FIELD REPORT – LYNNWOOD RECREATION CENTER – FIELD REPORT
REPORT #12

Job No. 10-100622B1

Date: January 3rd, 2014
Page 1 of 12

Job Site Address:
18900 44th Avenue West
Lynnwood WA, 98036

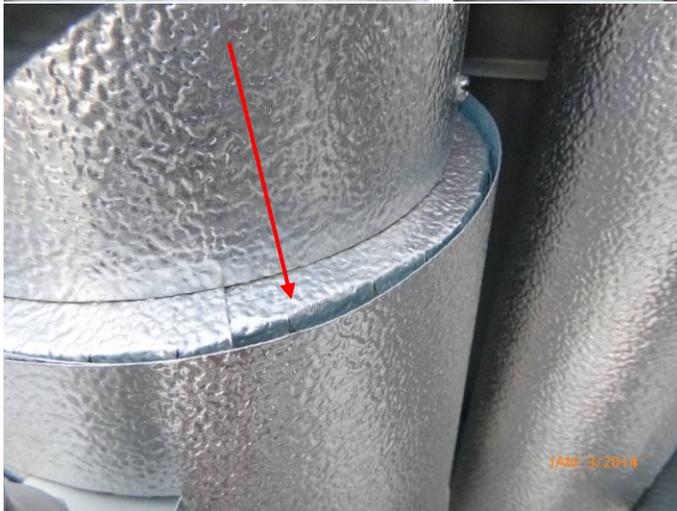
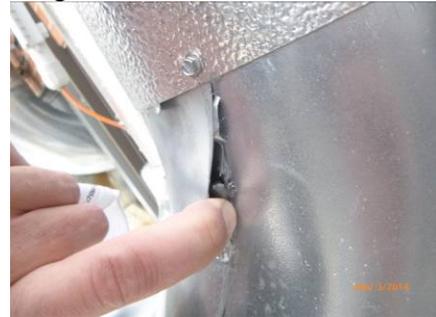
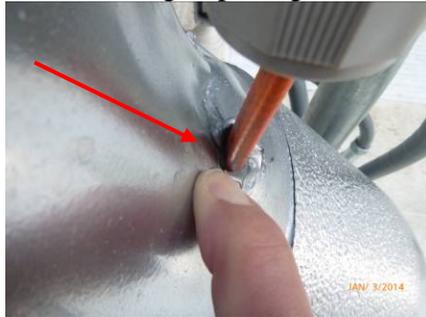
12.2 At the southeast corner of the penthouse the new insulated pipes are sloped towards the wall and the sealant joints that were recently installed appear to be failing. This writer is unable to determine if any other measures of flashing are present but recommends that a sheet metal enclosure of positive slope away from the wall be installed to shield the penetrations from the elements. Project detail 8/A101 calls for a sheet metal hood to cover multiple pip penetrations that should be installed.

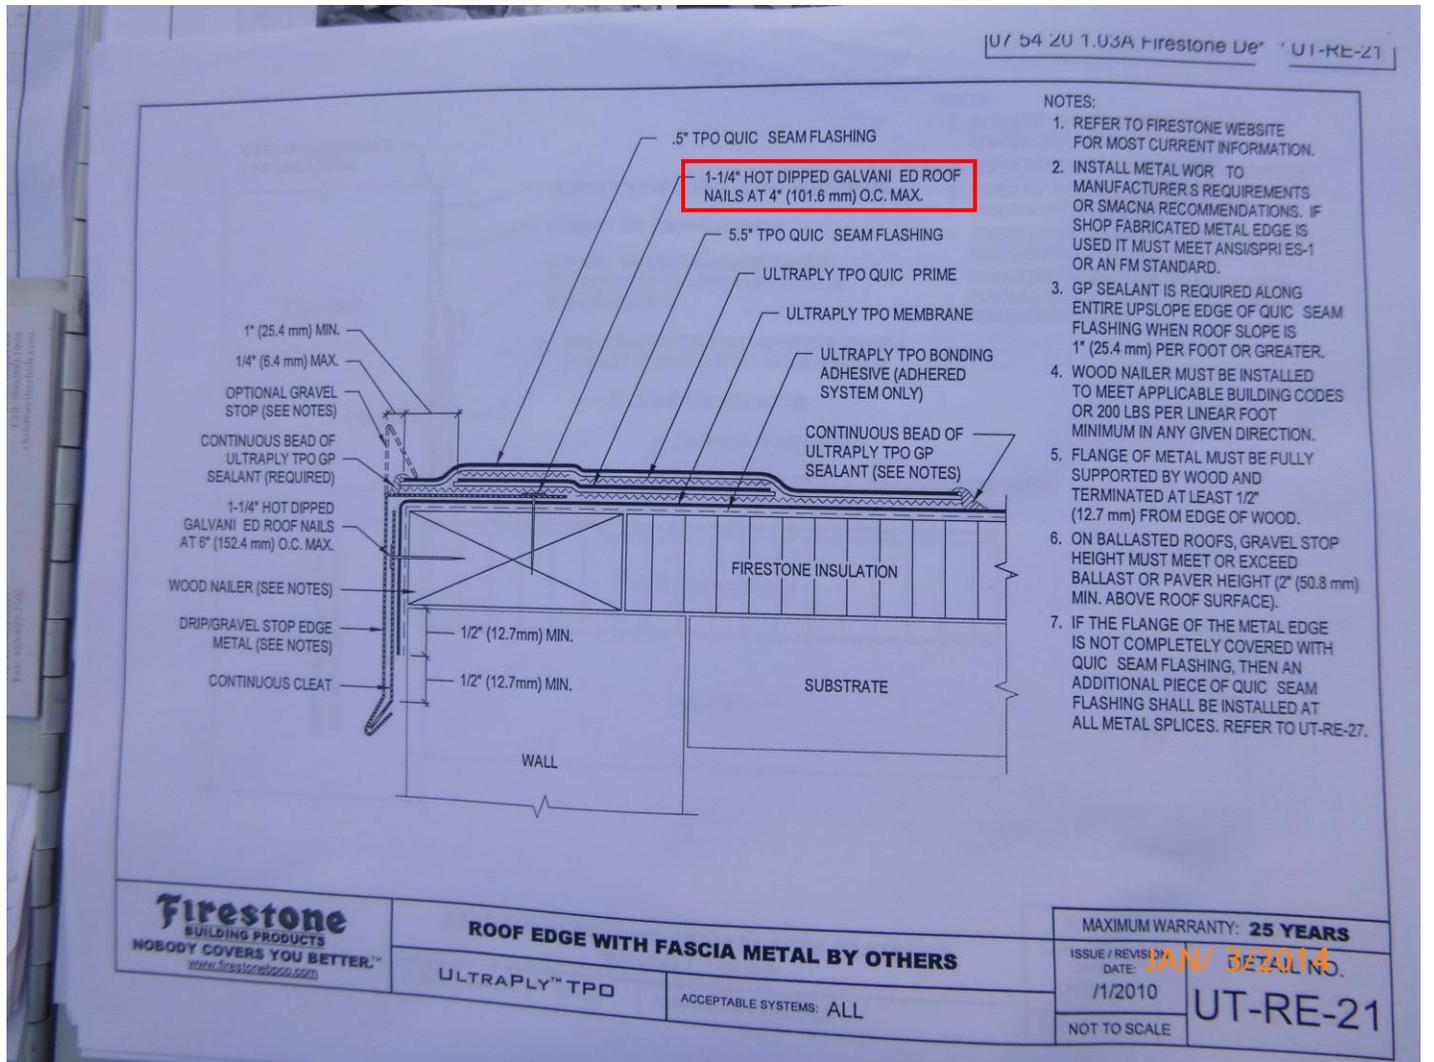
12.8 At the east side of the chiller room penthouse roof, the edge metal is fastened at approximately 14-inch intervals and should have been fastened every 4-inches on center per Firestone detail UT-RE-21 as shown below. Also, the detail calls for two layers of Quic Seam Flashing and it appears that only one was installed. Required fasteners and Quic Seam Flashing should be added to meet manufacturer’s requirements. The manufacturer should review and provide an approved repair detail.

Roof Progress Plan / Locator Map:

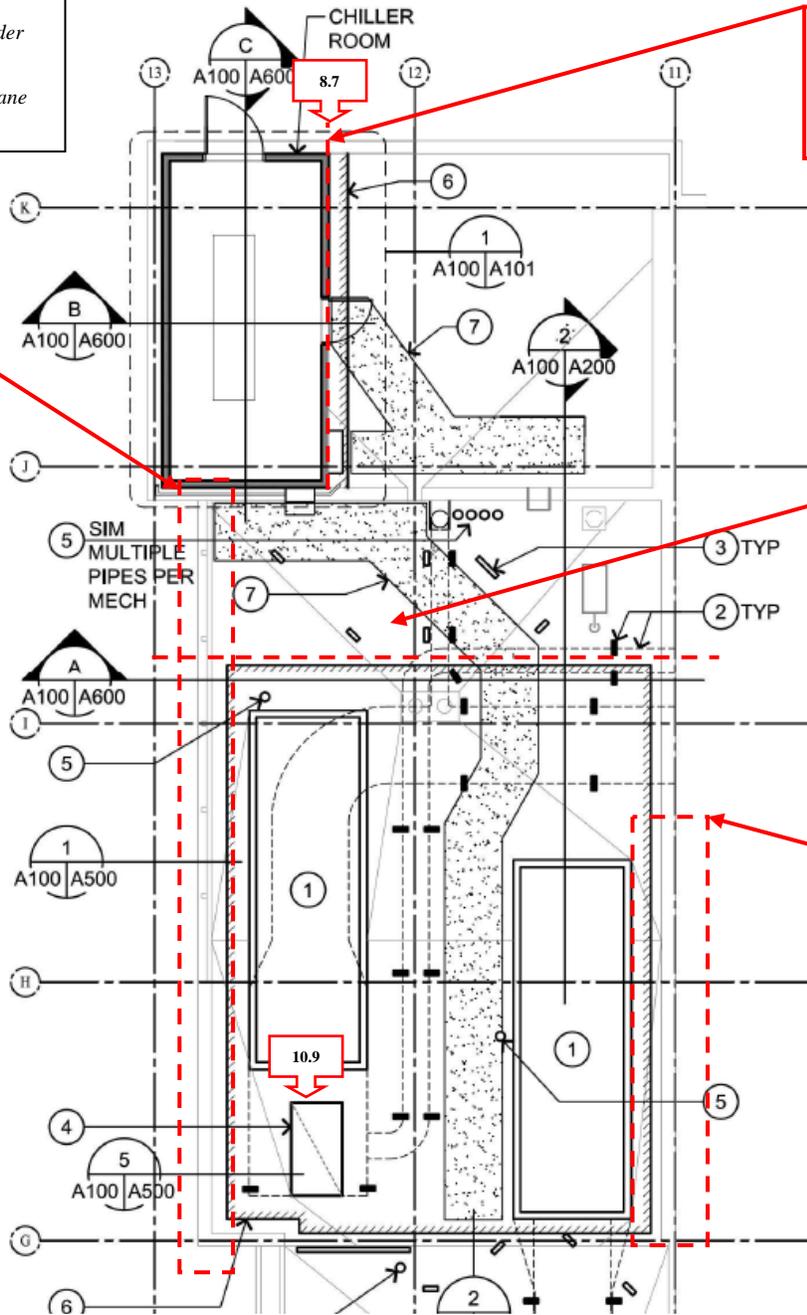
Item 8.4: Infill holes in top plates at screen wall structure.

Problems Item 8.8 – sheet metal re-installation at the upper steep slope roof to accommodate new HVAC.
